| Request           | - | Special Use Permit for a New Gas Station                             |
| Location          | - | North-East Corner of Dorr and Interstate 475                         |

SPECIAL USE PERMIT  
TOLEDO CITY PLAN COMMISSION  
REF: SUP-8002-23  
DATE: December 7, 2023  
TIME: 2:00 P.M.

# SITE PLAN

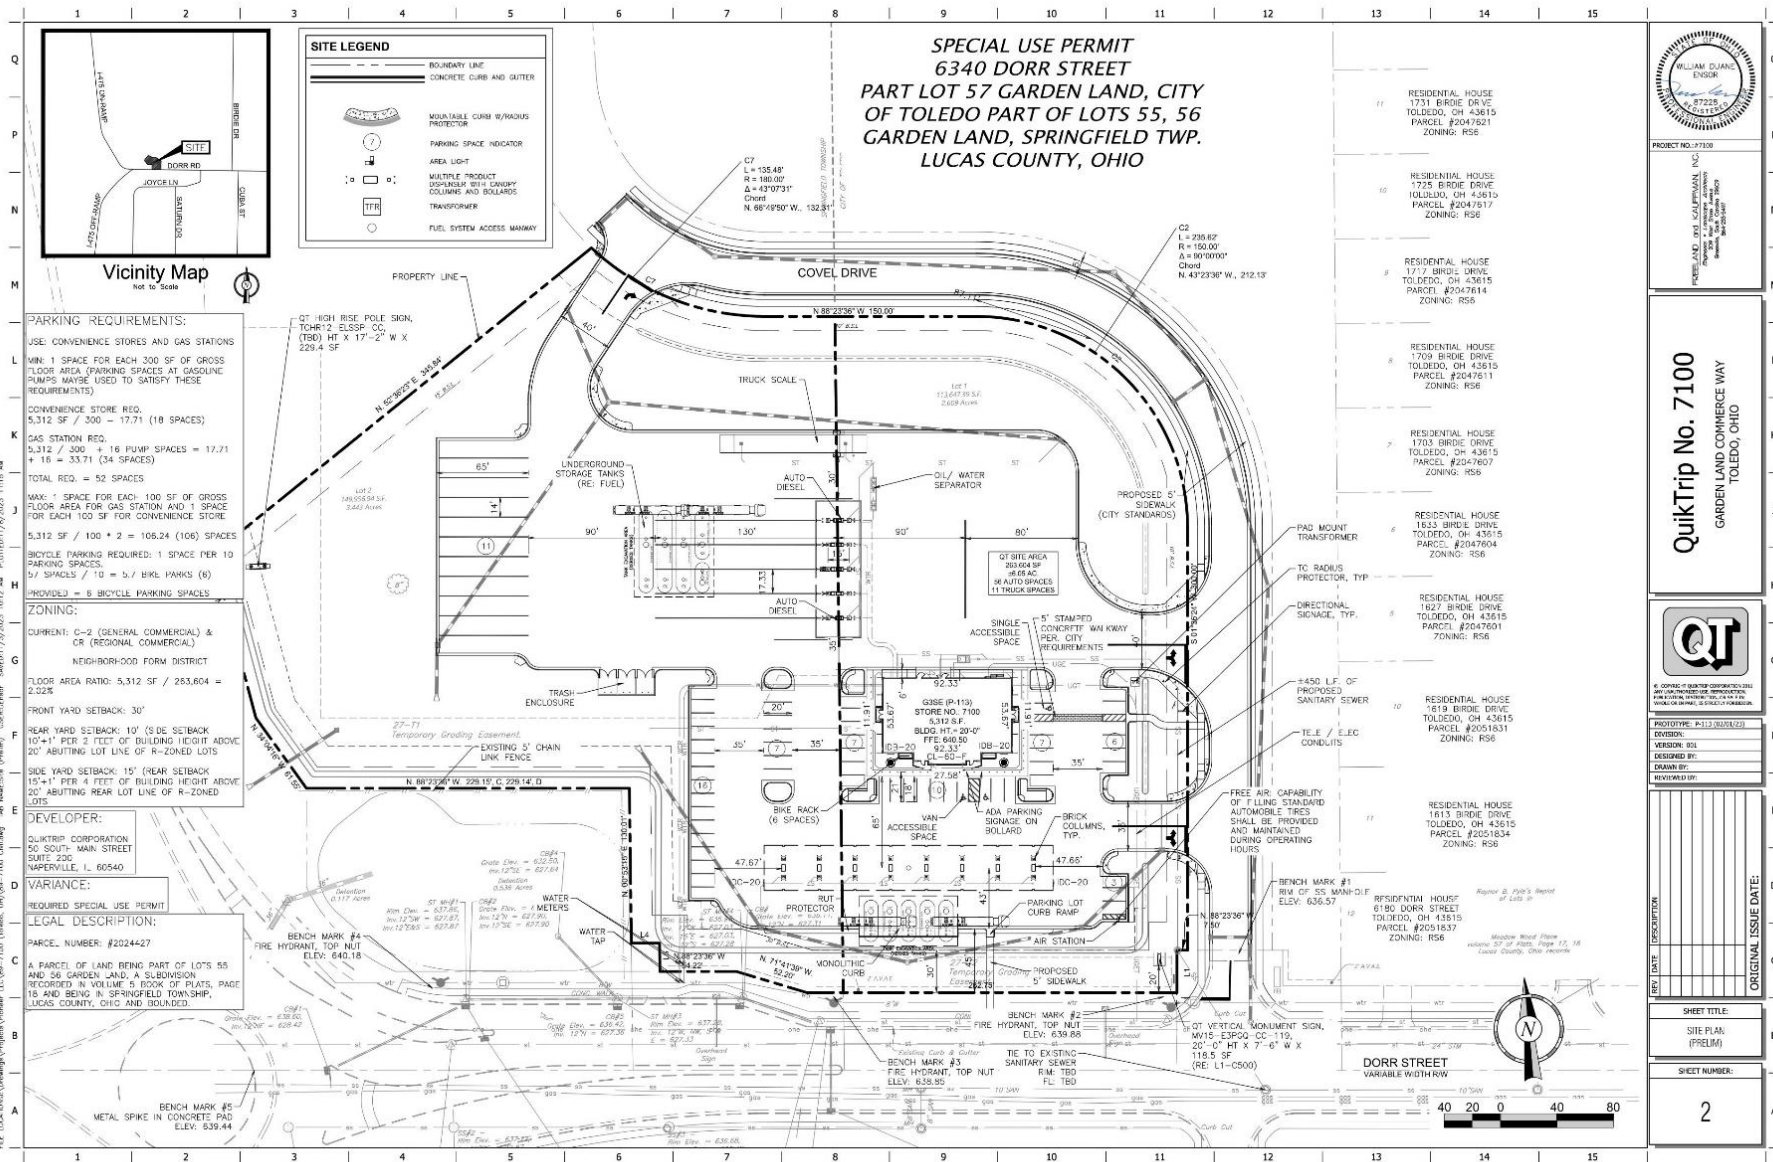
Pursuant to TMC§1107.0304 – *Parking, Loading, and Access*: Gasoline and Fuel sales are required to have one (1) parking space per pump plus one (1) per three-hundred (300) square feet of building area. The site plan shows eight (8) gas pumps along Dorr Street and five (5) auto diesel stations to the north of the site. Twenty-six at pump parking spaces are required for the use. The proposed building covers an area of 5,312 square feet requiring an additional seventeen (18) parking spaces. The submitted site plan shows fifty-six (56) parking spaces and eleven (11) truck parking spaces to the north of the site for the gasoline and fuel sales use. TMC§1107.1601 requires one stacking space for every gasoline pump island. The stacking spaces must be a minimum of ten feet (10') by twenty feet (20') in size. This is not acceptable as depicted. Stacking spaces with dimensions shall be shown on a revised site plan.

41. Per TMC§1107.1601 a pump island requires a minimum of one (1) stacking space. Twenty-six (26) stacking spaces shall be provided for this site. **Not acceptable as depicted on site plan. Stacking spaces shall be indicated on a revised site plan.**

42. Stacking spaces must be a minimum of ten by 20 feet (10'x20') in size. **Not acceptable as depicted on site plan. Stacking spaces with dimensions shall be indicated on a revised site plan.**

# LANDSCAPING PLAN

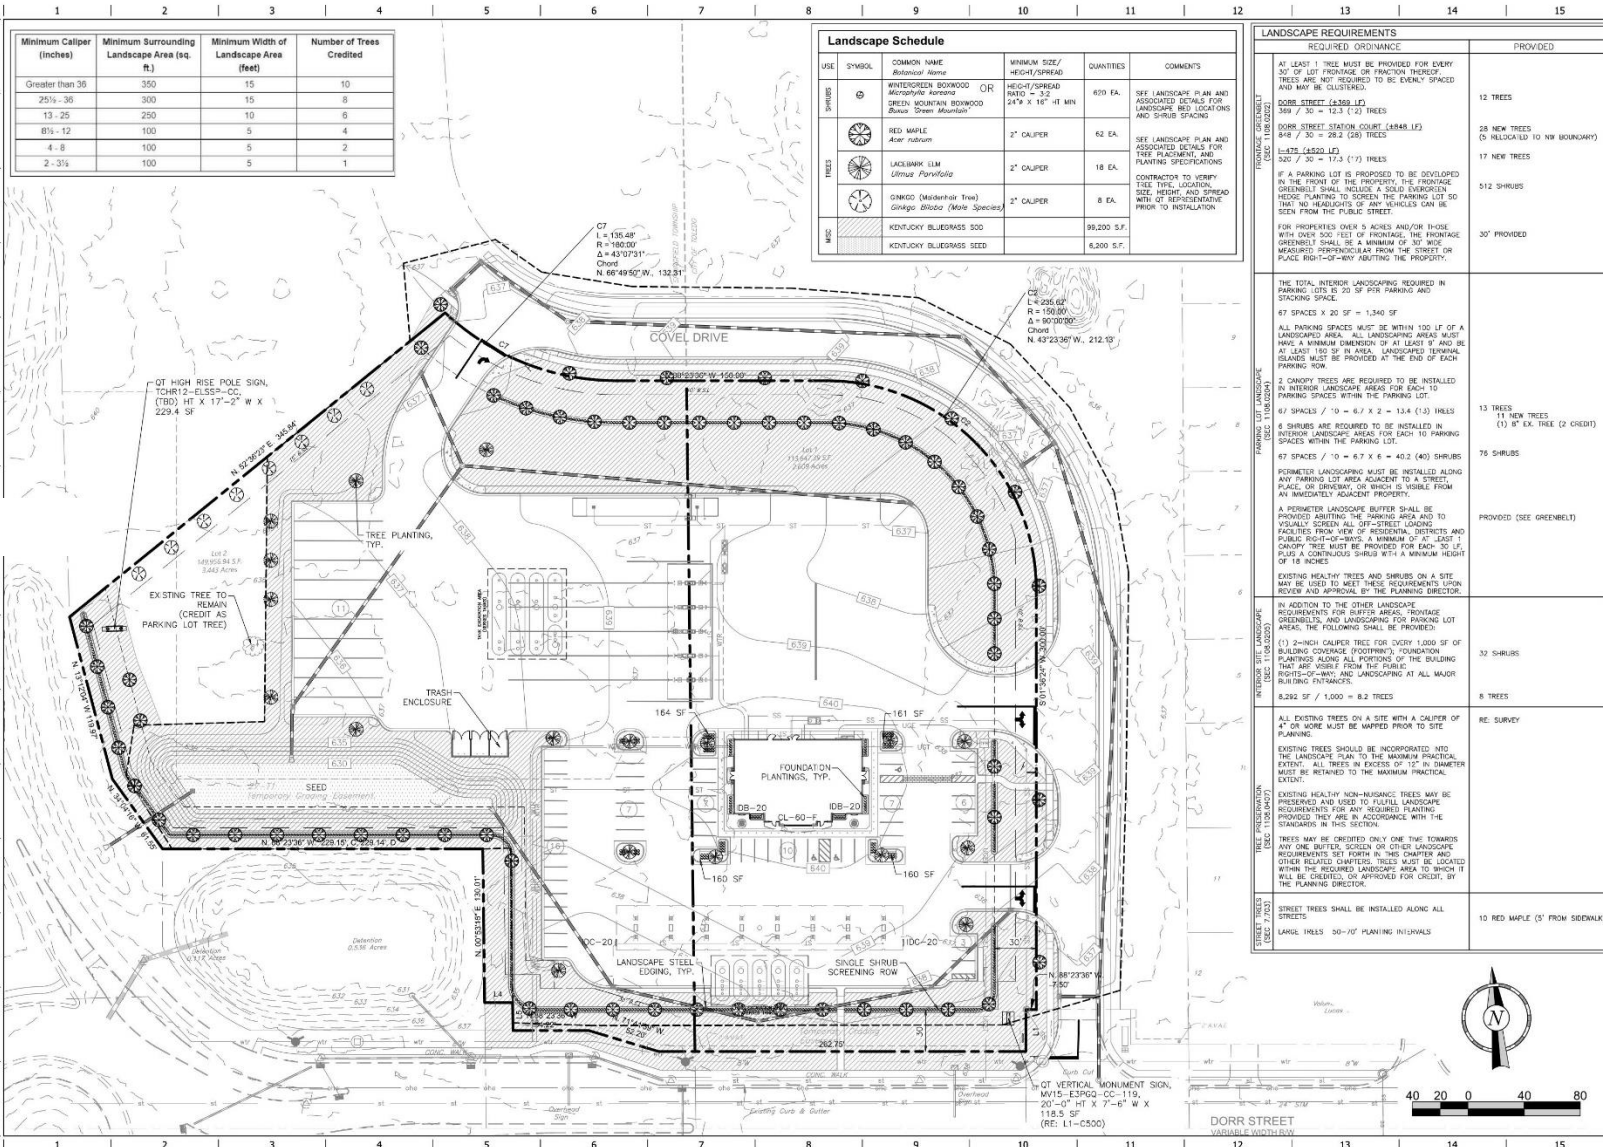
Per **TMC§1108.0202** a thirty-foot (30') greenbelt is required for properties over five (5) acres or with a frontage over five hundred feet (500'). At least one tree must be provided for every 30 feet of lot frontage or fraction thereof. The frontage greenbelt shall also include a solid evergreen hedge to screen parking in the front of the property and prevent headlights from being seen from the right-of-way. A thirty-foot frontage greenbelt buffer is required along Dorr Street, I-475 and Covell Drive. Twenty-six (26) trees and a continuous shrub shall be provided along Dorr Street for a frontage of  $\pm$  765 feet. In addition to that, the applicant is required to provide eighteen (18) trees along I-475 and thirteen (13) trees along Covell Drive. This requirement shall include a continuous shrub. The submitted site plan shows twenty-one (21), eighteen (18) and twenty-eight (28) with a continuous shrub along Dorr Street, Interstate 475 and Covell Drive. This is not acceptable as depicted on landscaping plan. Additional continuous shrub shall be provided along the property line fronting Interstate 475.

- a. A thirty-foot (30') buffer of landscaped frontage greenbelt is required along Dorr Street, Interstate 475 and Covell Drive. At least one tree must be provided for every 30 feet of lot frontage or fraction thereof. The frontage greenbelt shall also include a solid evergreen hedge to screen parking in the front of the property and prevent headlights from being seen from the right-of-way. Twenty-six (26) trees and a continuous shrub shall be provided along Dorr Street. In addition to that, the applicant shall provide eighteen (18) trees along Interstate 475 and thirteen (13) trees along Covell Drive. This requirement shall include a continuous shrub. **Not acceptable as depicted on site plan. Additional continuous shrub shall be provided along the property line adjacent to Interstate 475.**

# ELEVATIONS

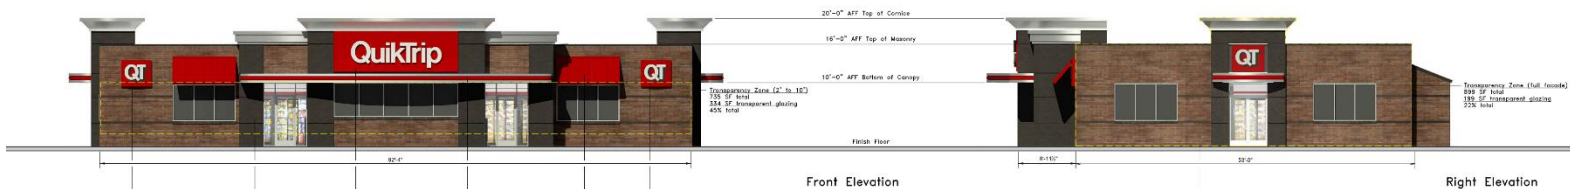
As required under **TMC§1109.0500** – *Building Façade Materials and Color*, the submitted elevations shows the southern façade visible from Dorr Street being 42% brick, 11% architectural metal, 22% glass and 15% EIFS and 10% signs. The wall facing Interstate 475 is composed of 74% brick, 5% architectural metal, 11% EIFS and 10% glass. The north portion of the building is made up of 95% brick and 5% brick. The east façade consists of 64% brick, 5% architectural metal, 20% glass and 11% EIFS. All building material standards apply to all façades that are visible from the right-of-way, the proposed elevations are compliant.

49. Building elevations are subject to TMC§1109.0500 – Building Façade Materials and Color. **Proposed elevations received November 9, 2023 are acceptable as depicted.**
